CITY OF CONWAY, ARKANSAS HISTORIC DISTRICT COMMISSION

March 22, 2021 · 5:30pm

P.F. Cleaver House Exterior Modification

New Accessory Structure

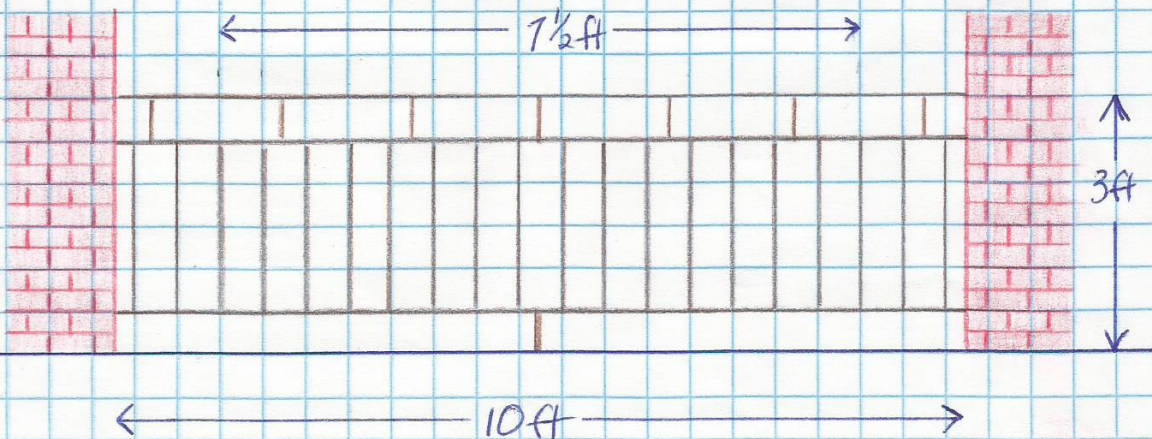
The proposed railings are compatible with the design, but do not represent an exact match of what would have been historically placed on the structure. This approach is appropriate to the structure such that it helps denote the railings are not a historic element on the home.

Staff recommends approval of porch and step railings.

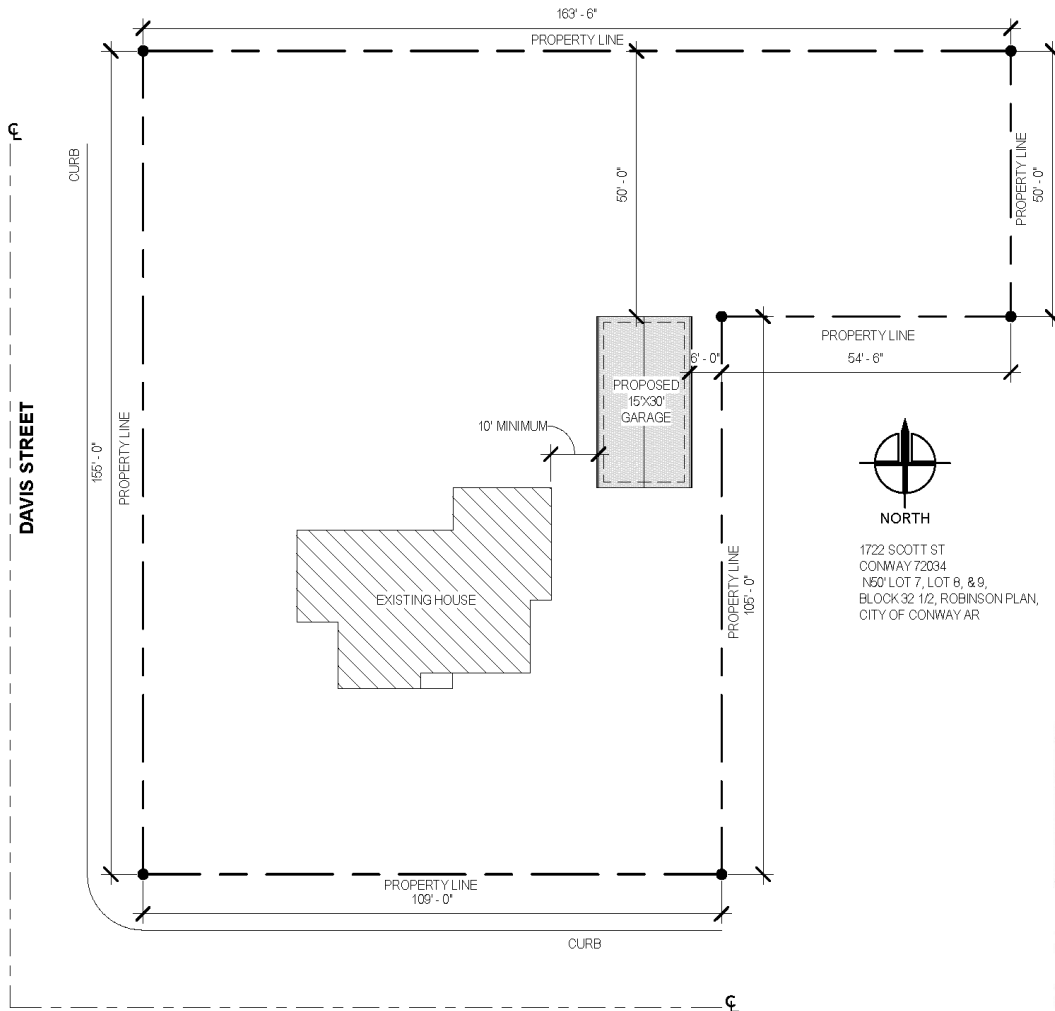
The structure is proposed to be placed behind the primary structure with a proposed side setback of 6 feet.

The proposed carport is placed at the rear of the structure in an appropriate manner.

Tree preservation. It is unclear if any trees will be impacted by the construction, need further information from the applicant.

The driveway appears to have been paved without approval. However, the width appears appropriate.

Recommend requiring a tree planting if any trees over 8" in diameter are removed.

Staff recommends approval of the application.

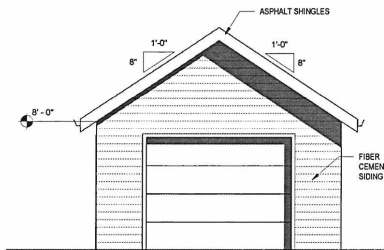
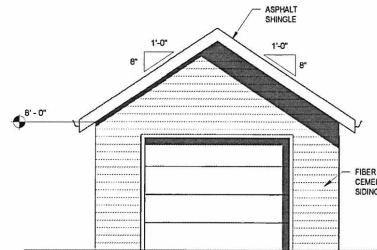
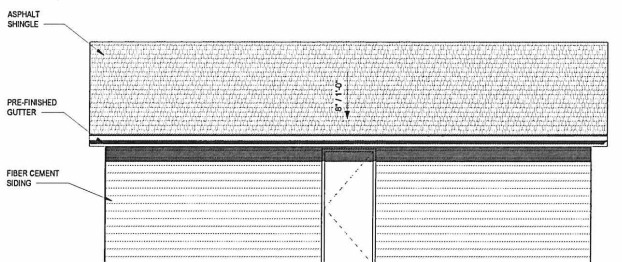
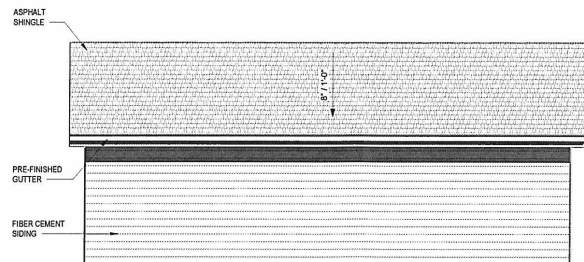
The proposed roofing materials and slopes for the garage are appropriate.

The applicant is proposing Hardieboard siding for the garage. This material is appropriate. A wood equivalent product such as LP Smartside is also appropriate.
